Comments on Annex 113A

Page 205, Figure 113A-3: Technical (Illustrative example)

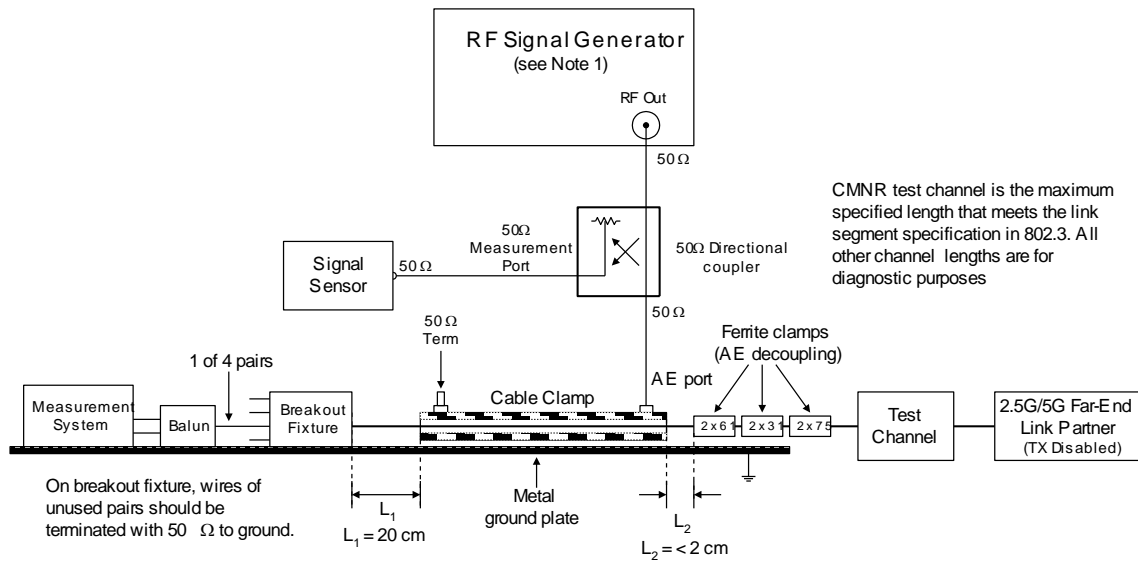
Proposed modification to add directional coupler at clamp input:

Important note: This figure is not intended to be copied exactly into the standard document. Its main purpose is to show the insertion location for the added directional coupler.

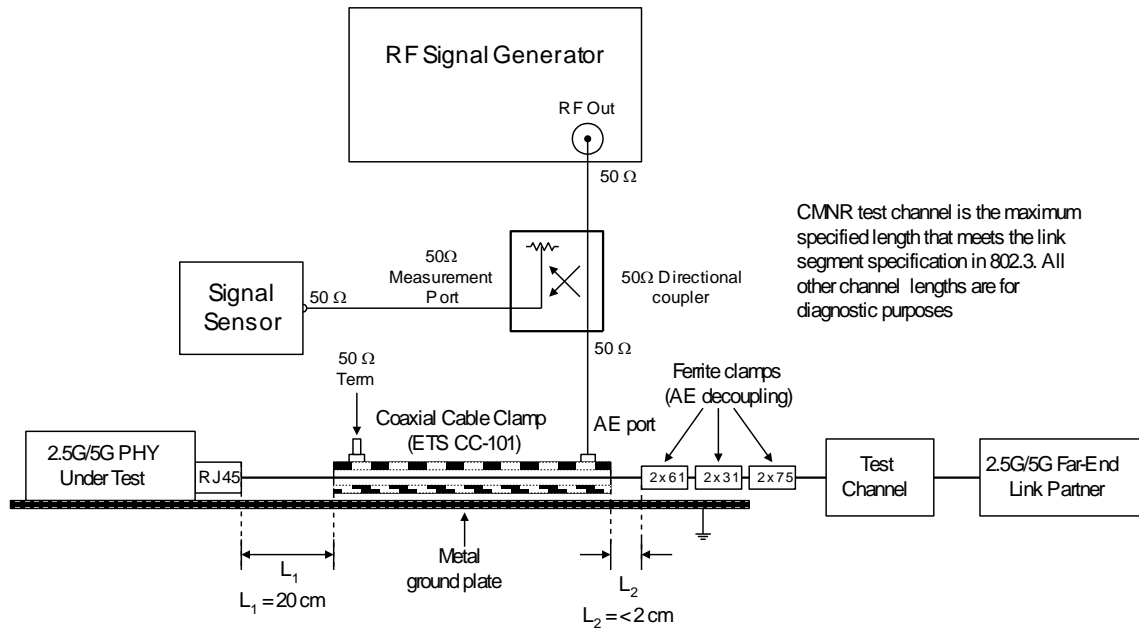
Proposed modification to add directional coupler at clamp input:

Important note: This figure is not intended to be copied exactly into the standard document. Its main purpose is to show the insertion location for the added directional coupler.
